Addendum No. 03

Clovis East Soccer Complex

PBK PROJECT NO.: S2103100AR
DSA FILE NO.: -
DSA APPLICATION NO.: 02-120099, 02-120158, 02-120503

BLEACHERS/ STADIUM LIGHTING/ SCOREBORAD DRAWINGS:

ELECTRICAL SITE PLAN & PRESS BOX PLAN

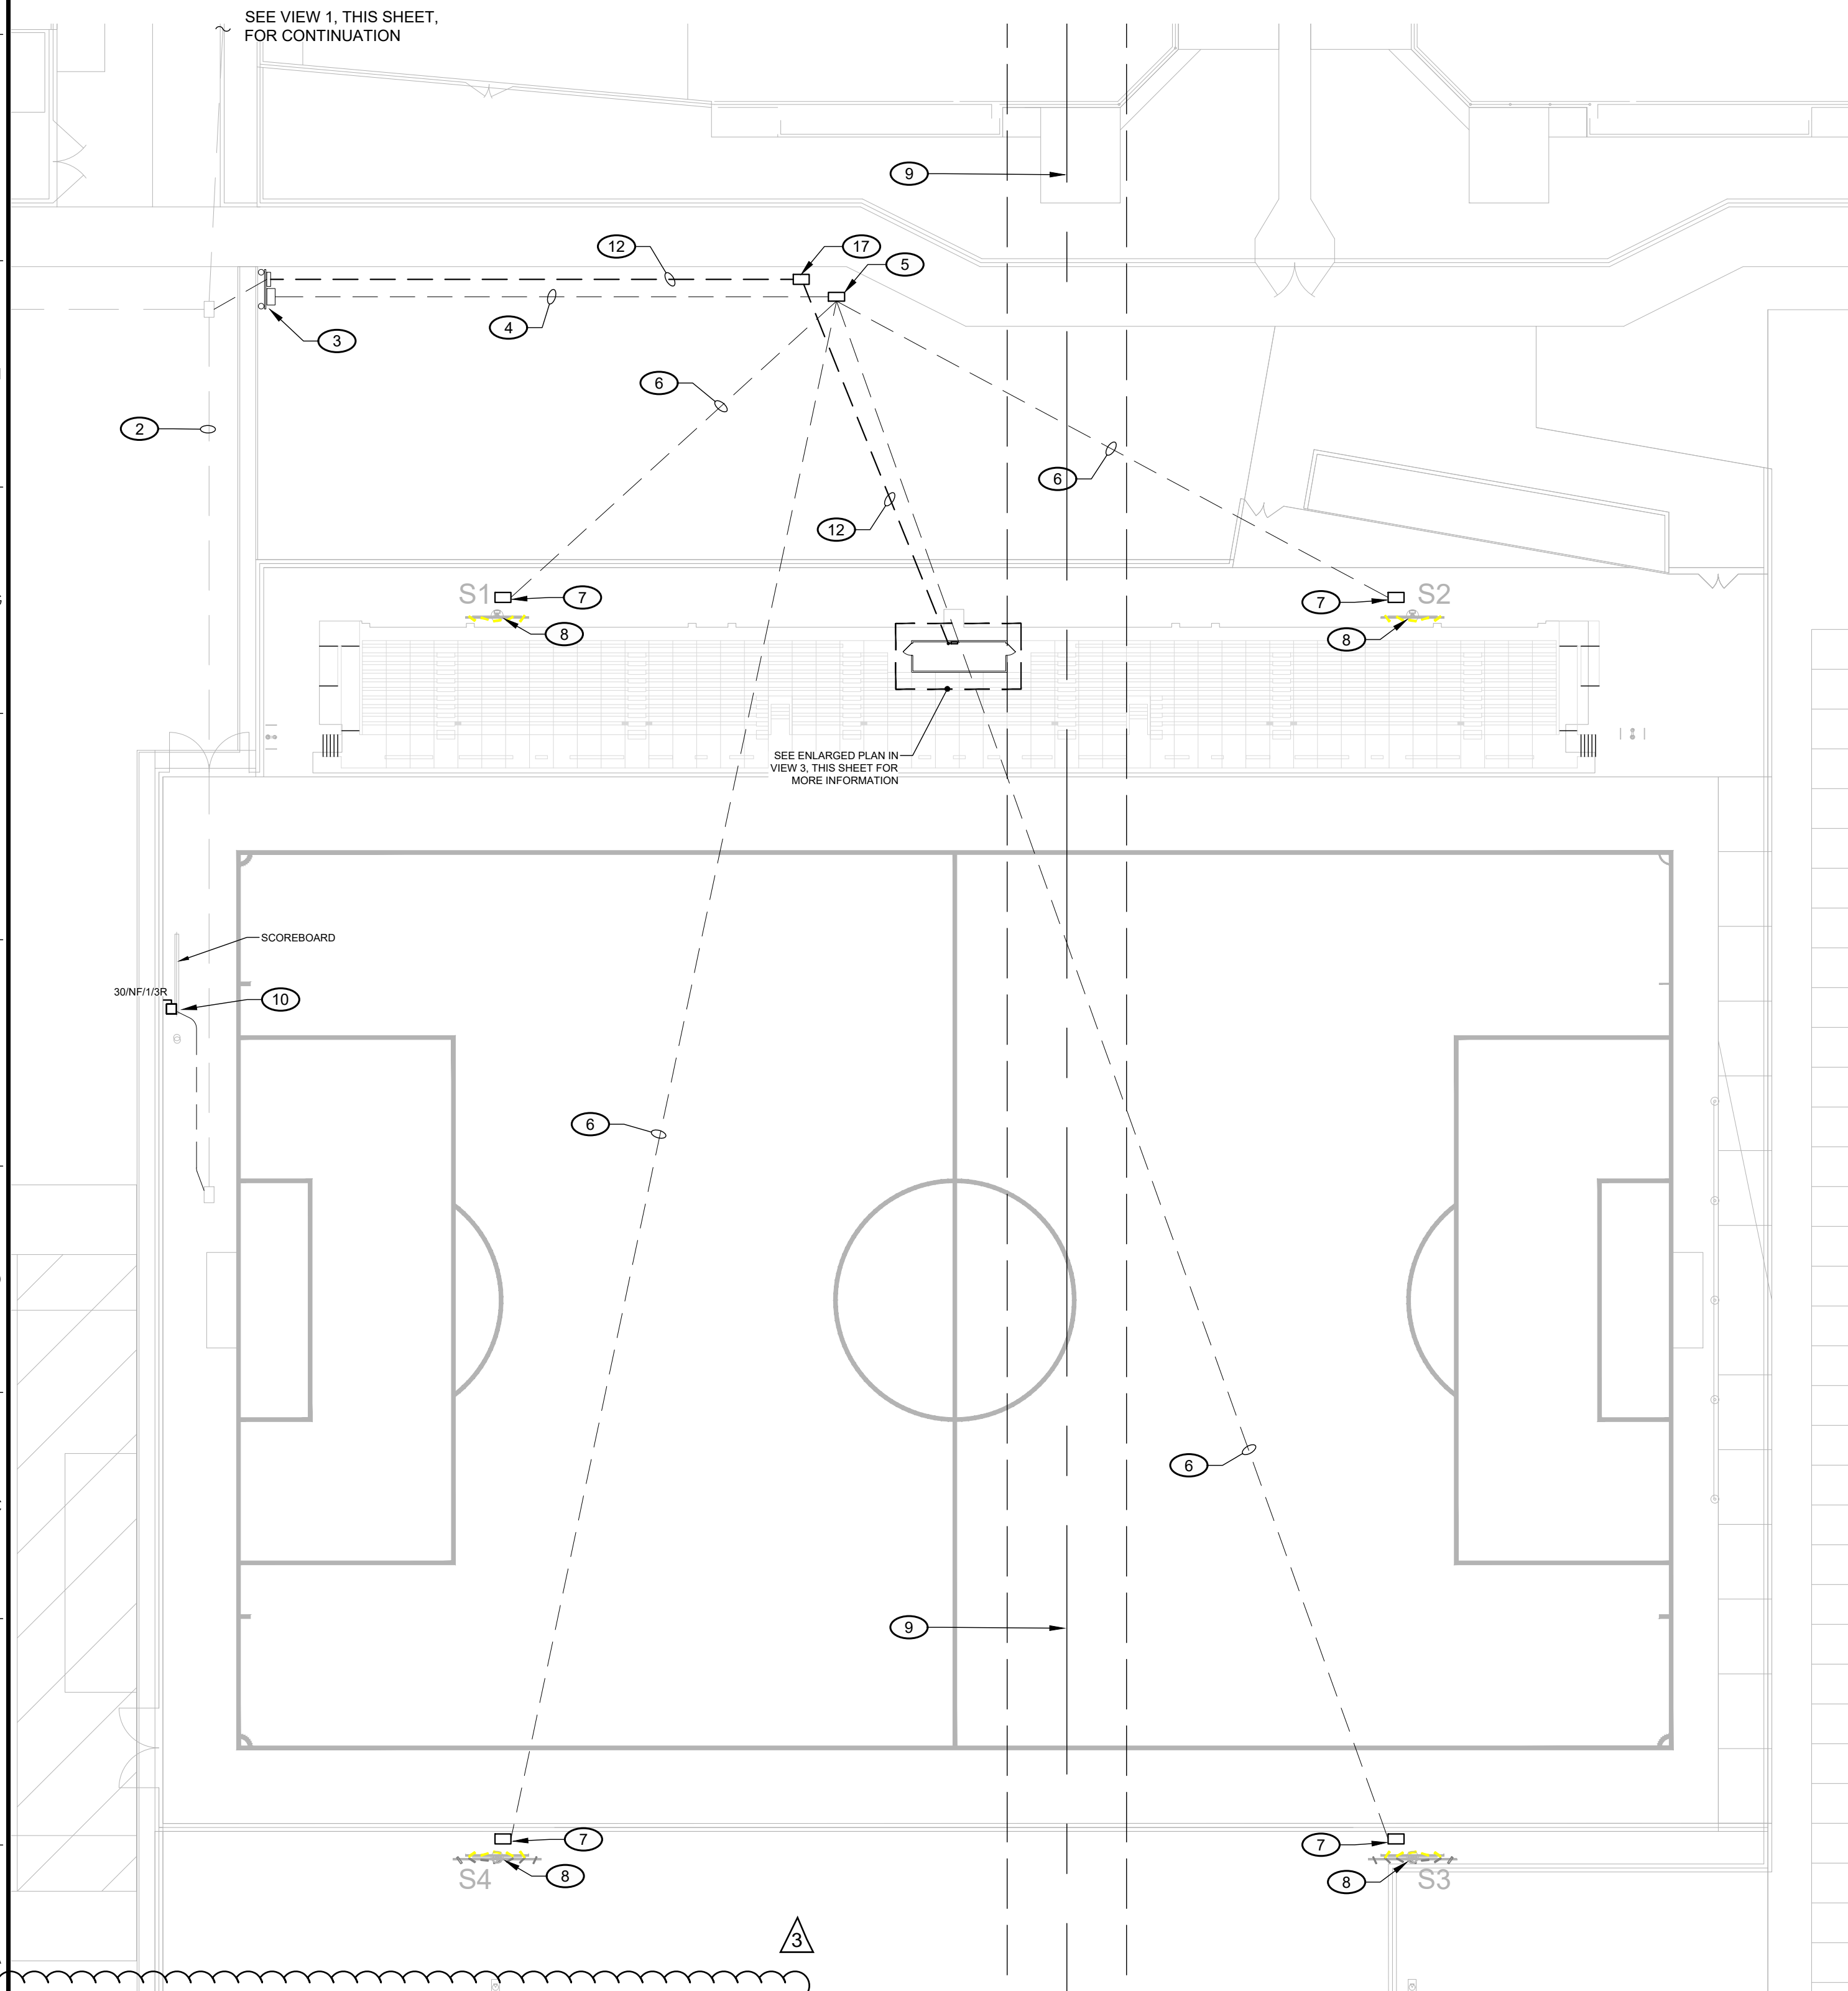
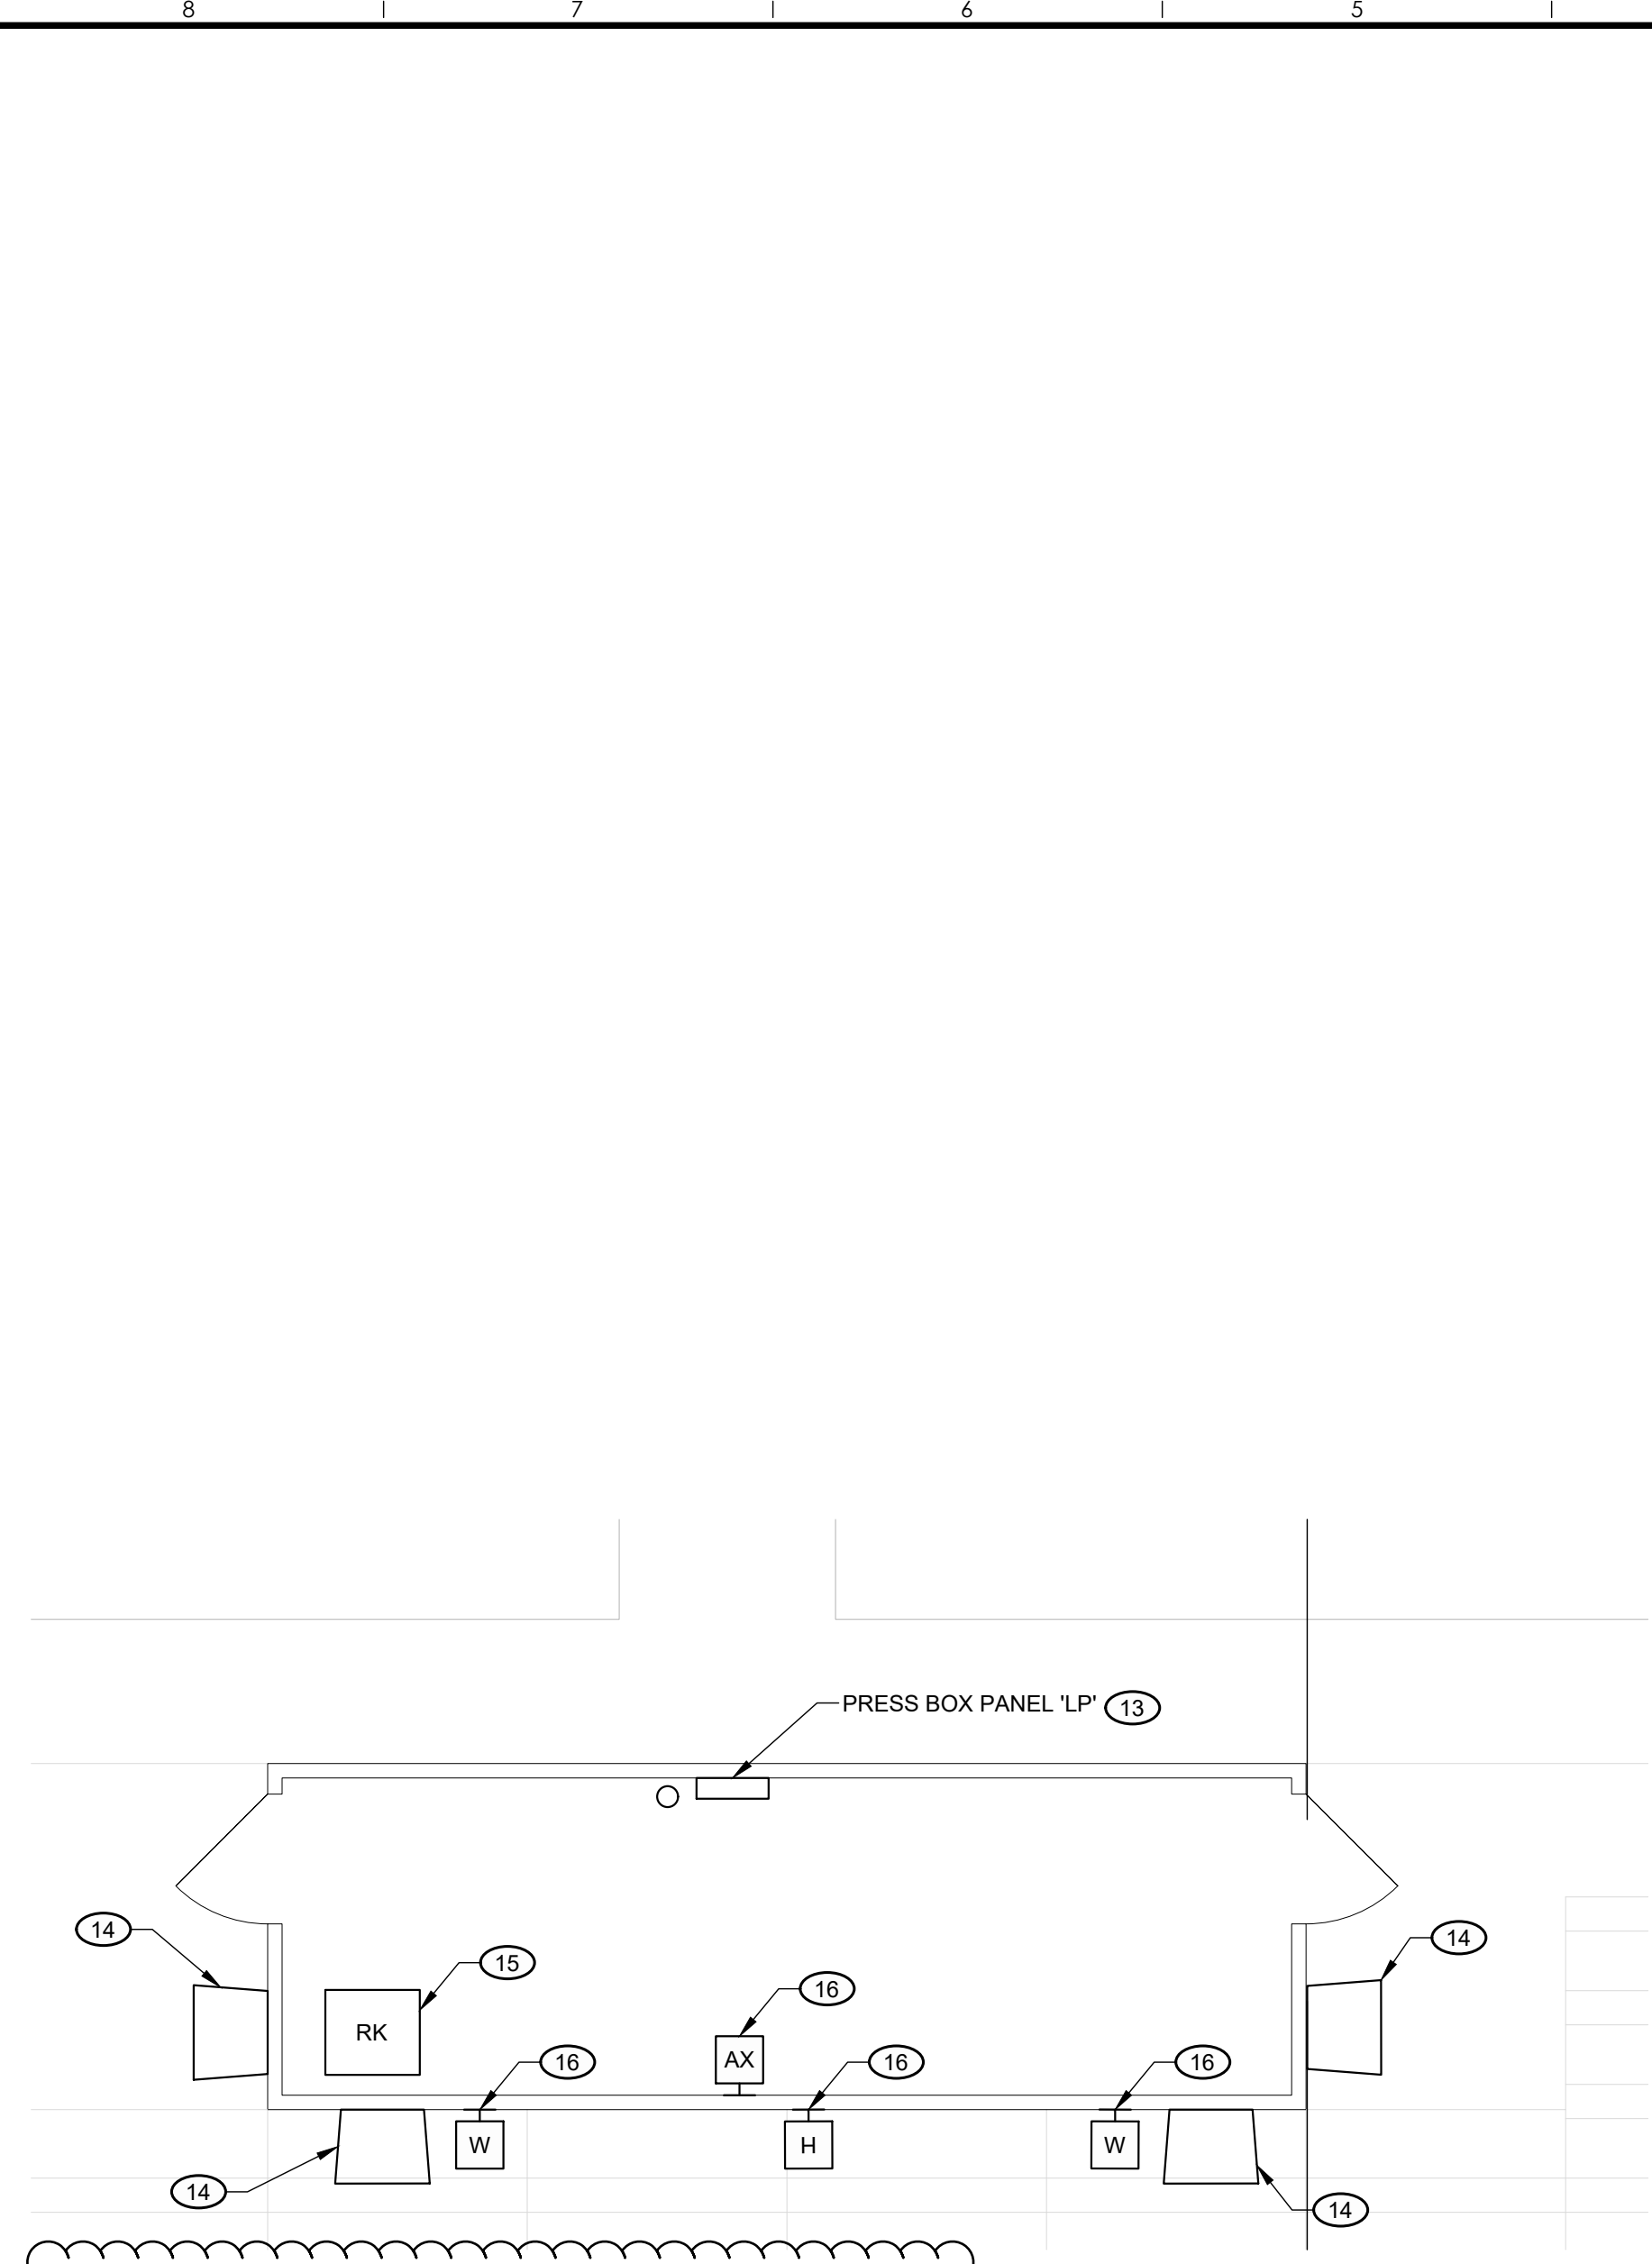
- 3-01 Sheet E0.1 – ELECTRICAL SHEET INDEX, LEGEND & NOTES**, revise as follows:
Add Sheet. See attached
- 3-02 Sheet E1.0 – ELECTRICAL SITE PLAN & PRESS BOX PLAN**, revise as follows:
Revised plans. See attached.
- 3-03 Sheet E6.1 – ELECTRICAL SINGLE LINE DIAGRAM**, revise as follows:
Revised diagram. See attached.
- 3-04 Sheet EX1 – ELECTRICAL DETAILS**, revise as follows:
Adde sheet. See attached.

- 1 EXISTING ELECTRICAL SWITCHBOARD "1A". PROVIDE NEW CIRCUIT BREAKER FOR THIS PROJECT. REFER TO THE SINGLE LINE DIAGRAM.
- 2 EXISTING 2" CONDUIT SPARE TO BE USED FOR THIS PROJECT. INSTALL NEW ELECTRICAL SUPPLY FEEDER PER THE SINGLE LINE DIAGRAM.

- 3 PROVIDE NEW EQUIPMENT BACKBOARD WITH PANELS 'SF-1' AND 'SF-2' AND 25 KVA TRANSFORMER 'SF' PER THE SINGLE LINE DIAGRAM. INSTALL THE SPORTS LIGHTING CONTROL PANEL PER THE SPORTS LIGHTING VENDOR PLANS. SEE DETAIL 06/EX.1 FOR MORE INFORMATION.

- 4 PROVIDE (2) 2" CONDUITS FOR SPORTS LIGHTING CIRCUITS. REFER TO THE SINGLE LINE DIAGRAM. SEE DETAIL 05/EX.1 FOR TYPICAL TRENCH DETAIL.
- 5 PROVIDE NEW FLUSH IN-GRADE PULL BOX. 30"X 42" (MINIMUM), INCIDENTAL TRAFFIC LID. SEE DETAIL 04/EX.1 FOR UNDERGROUND PULL BOX DETAIL.
